Subject: AP1000 COL Responses to Requests for Additional Information (TR #44)

In support of Combined License application pre-application activities, Westinghouse is re-submitting the non-proprietary responses to NRC requests for additional information (RAI) on AP1000 Standard Combined License Technical Report 44, APP-GW-GLR-026, Rev. 0, New Fuel Storage Rack Structural/Seismic Analysis. These RAI responses are submitted as part of the NuStart Bellefonte COL Project (NRC Project Number 740). The information included in the responses is generic and is expected to apply to all COL applications referencing the AP1000 Design Certification.

Responses to Requests for Additional Information on Technical Report No. 44

RAI Response Number: RAI-TR44-005
Revision: 0

Figure TR44-005.1 Fuel Assembly Deep Drop Scenario 1 for New Fuel Rack

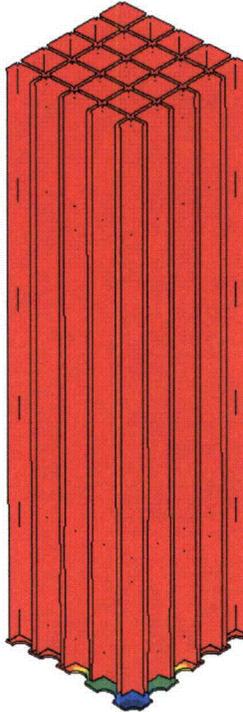
Section 2.8.5 does not indicate whether other fuel assemblies are in place, when a fuel assembly drops through an empty cell and impacts the baseplate at its center. Depending on how the baseplate is designed, a full load of fuel assemblies may introduce progressive deformation after a fuel assembly impacts at the center of the baseplate. The maximum downward deformation of the baseplate is about 3.8 inches, as shown in Figure 2-10. This may be significant enough to initiate a progressive deformation. Therefore, provide: (1) the assumption on the existing fuel assemblies when the impact occurs, (2) the design basis for the baseplate, and (3) a figure similar to Figure 2-10, that shows the cells together with the severely deformed baseplate.

- (3) Figure TR44-005.1 below shows the cells together with the severely deformed baseplate for the same LS-DYNA solution as shown in Figure 2-10. Note that the deformation of the cells is not significant compared to the baseplate. This is because the cell-to-baseplate weld connections break as a result of the postulated fuel impact load before the cell walls are permanently deformed.

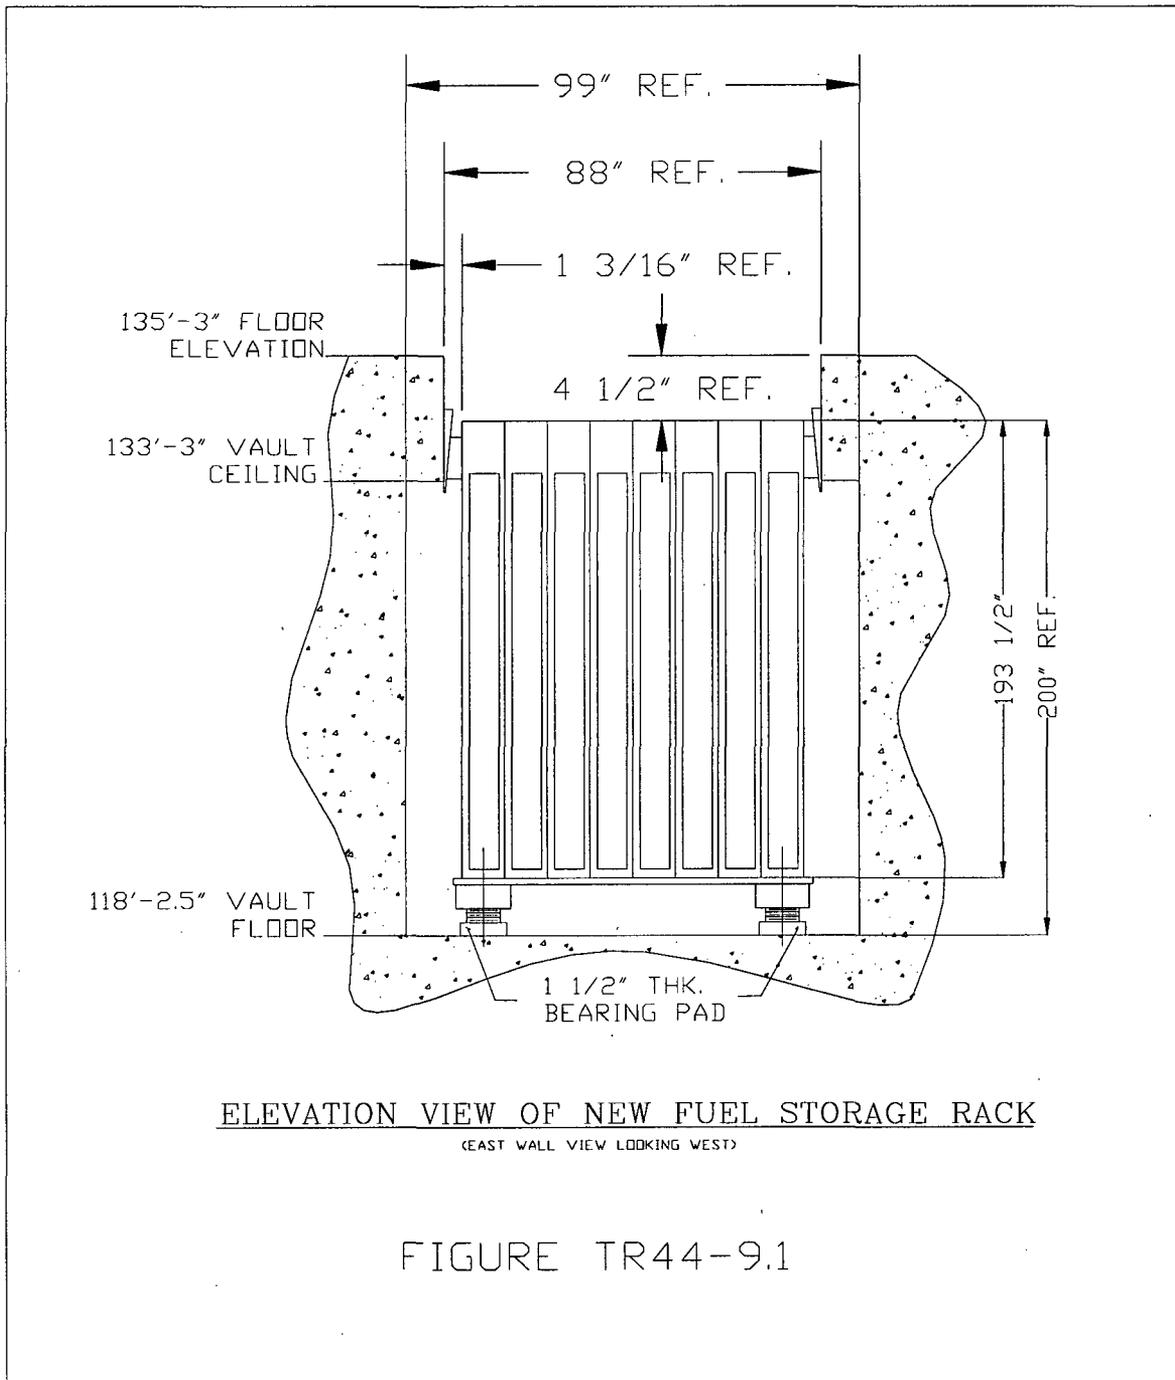
Insufficient descriptive information has been included in the new fuel report to permit an adequate review of the structural/seismic analysis of the new fuel rack. Please provide descriptive information including plans and sections showing the new fuel rack and vault walls. All of the major features of the rack including the cell walls, baseplate, pedestals, bearing pads, neutron absorber sheathing, any impact bars, welds connecting these parts, and any other elements in the load path of the rack should be shown on one or several sketches. These sketches should also indicate related information which includes key: cutouts, dimensions, material thicknesses, and gaps (fuel to cell, rack to walls). In addition to the above, for review of postulated fuel handling drop accident and quantification of the drop parameters, sketches with sufficient details for the fuel handling system should be provided.

Figures TR44-9.1 through TR-44-9.5 provide additional descriptive information on the new fuel rack and New Fuel Storage Pit floor and walls. The new fuel handling system is still in final design and no sketches are available. The quantification of the drop parameters has been established and analyzed in Technical Report Number 44. A conservative drop height of 36 inches has been assumed even though the most likely drop height will not exceed 18 inch above the new fuel rack. The total drop weight is 2,027 pounds, which consist of a new fuel assembly, control assembly and new fuel handling tool.

1. The new fuel storage rack is braced against the north and south walls of the New Fuel Storage Pit by inserting stainless steel wedges in the interstitial space between the top of the new fuel storage rack and the New Fuel Storage Pit opening (see TR44-009 RAI Response Figure TR44-9.1).
